SUBJECT: Forwards response to NRC request for addl info on LAR 97-11 re auxiliary saltwater sys piping bypass unreviewed safety question.

Docket No. 50-275, OL-DPR-80
Docket No. 50-323, OL-DPR-82
Diablo Canyon Units 1 and 2
Response to NRC Request for Additional Information on License Amendment
Request 97-11, Auxiliary Saltwater System Piping Bypass Unreviewed Safety
Question

**NRC Mechanical Engineering Branch Request for
Additional Information on Auxiliary Saltwater System Piping Bypass Project**

Diagram 5a-2

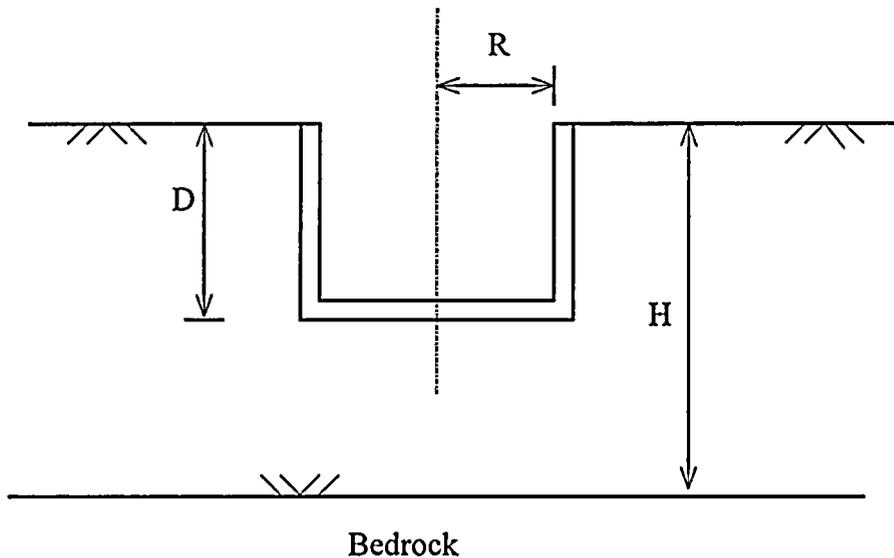
- a. Provide the detailed basis and calculation of the axial and transverse soil springs stiffnesses.

The stiffness of transverse soil springs attached to concrete thrust blocks is estimated using equations from Reference 5a-2 for an equivalent, rigid, embedded cylindrical foundation that accounts for the embedment effect of the soil as shown below:

Sample Calculation for Horizontal Soil Spring for Thrust Block E-1

For example, the horizontal soil spring for the thrust block near the Intake Structure, E-1, as shown on Figure 5b-1 of our response of May 15, 1997 (i.e., same as March 25, 1997 response), is calculated as follows:

Thrust Block Dimensions $L = 15 \text{ ft}$ $B = 15 \text{ ft}$ $D = 10 \text{ ft}$
 $H = 25 \text{ ft}$
 $\nu = 0.4$
 $G = 4092 \text{ ksf}$

Figure 5c-1 Hosgri Differential Displacements for Pipe Segment Between E and I

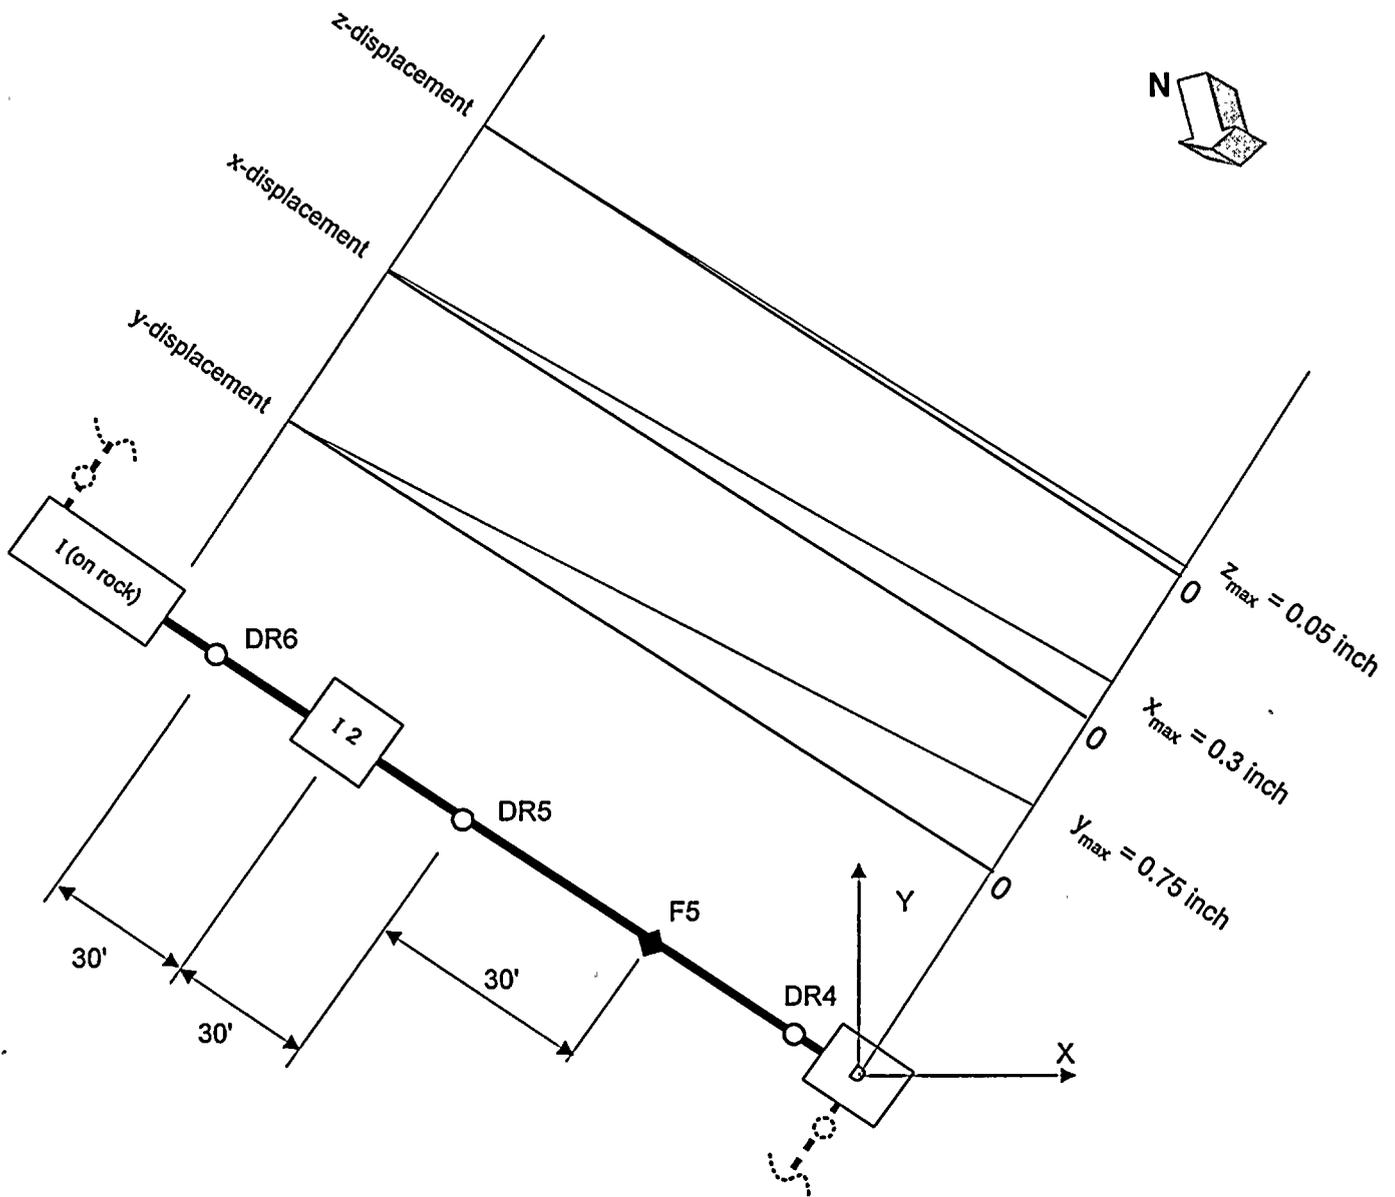
For the buried piping system shown in Figure 5b-1 of your response of March 25, 1997, to an NRC request for information:

c. Provide the values of the input displacements to the piping analysis under the following loading conditions:

- Dead Loads
- Soil Settlement Loads
- Seismic Loads (HE)
- Soil Liquefaction Loads
- Tsunami Loads

The differential input displacements transverse to the buried piping for the governing Hosgri earthquake are given in Figures 5c-1 through 5c-3. As described in the response to Question 4, input displacements shown in Figure 5c-1 correspond to the best estimate soil properties, while the balance of the bypass piping segments use the more conservative displacement input from lower bound soil properties. In the direction parallel to the piping, the maximum displacements (corresponding to the lower bound V_s) were used for evaluation of the Dresser couplings.

(1) Segment between Intake Structure and Point I:

Expected ground movement at the end points of this piping segment is negligible compared to the soil in between since both the Intake Structure and the concrete thrust block at Point I are on bedrock. As shown in Figure 5c-1, differential soil displacement patterns in the transverse directions are conservatively taken as triangular-shaped, with the maximum value at the apex corresponding to the maximum soil displacement relative to the Intake Structure. As far as local stresses are concerned, the triangular pattern selected is more limiting than a more gradual transition, such as a parabola, due to the more abrupt slope change at the apex. For this reason, at points of changing curvature in a given displacement pattern, the more abrupt transition scheme mentioned above, is conservatively applied in lieu of a more gradual transition.

To account for variability in the location of the maximum displacement, the point of application of the maximum displacement is varied ± 8 feet away from the hinge location (Dresser coupling) for this approximate 90 foot-long segment of piping.

Dresser Coupling
24 1/2" O. D. Style 38 Coupling

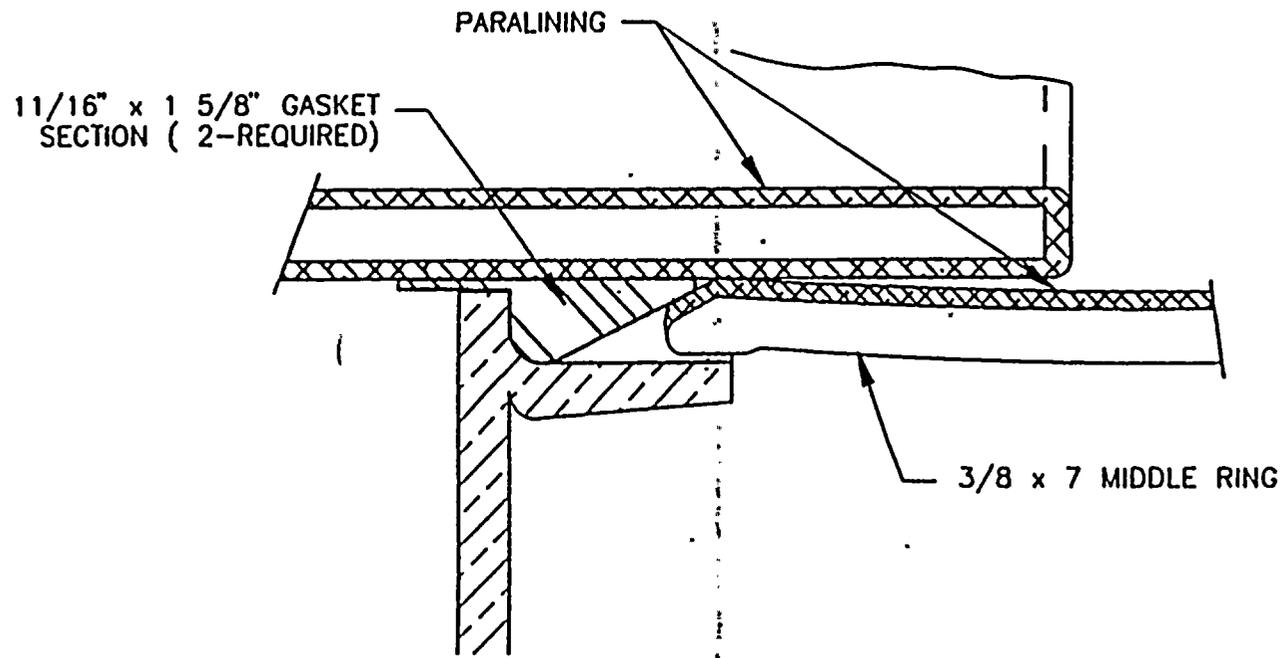
Provide detailed justification to demonstrate that the Dresser couplings will function under simultaneous internal pressure and the largest expected dynamic axial displacement.

The Diablo Canyon Power Plant (DCPP) application of the Dresser 24.5 inch, Style 38 coupling requires the ability to withstand cyclic movement of the pipe inside the coupling. Full scale cyclic testing was performed with the pipe "dry" followed by hydrostatic testing at 150 psig. The highest system operating pressure is 102 psig, while the Dresser coupling working pressure specified by the manufacturer is 378 psig. The required displacement for the Hosgri qualification test was 1.5 inches. The maximum displacement requirement for the Hosgri earthquake load combination is calculated as 1.1 inches (Reference 2-1).

The pressure retaining design of the coupling does not rely upon internal pressure to seal. The gaskets of the coupling are well confined within the annular space between the follower rings and the middle ring. (See attached sketch of Dresser coupling, Attachment 2-1.) The surface area of the gasket exposed to internal pressure is small. Internal pressure does not result in forces upon the coupling or gaskets that would tend to unseat the gasket or influence the sealing surfaces during displacement.

Movement occurs between the pipe surface (Paraline) and gasket. The gasket and middle ring do not move relative to one another. The most likely potential failure mechanism would be "rolling" of the gasket on the pipe disturbing the gasket/middle ring seal. This is prevented by reducing the friction between the Paraline and the gasket to near zero by a lubricant applied to the pipe surface during assembly (Reference 2-2). The potential for chafing or tearing the gasket is similarly reduced by application of the lubricant. The presence of internal pressure is not expected to significantly affect any of these potential failure mechanisms. The function of the seal was not disturbed by cyclic displacements as proven by a hydrostatic test after dynamic tests.
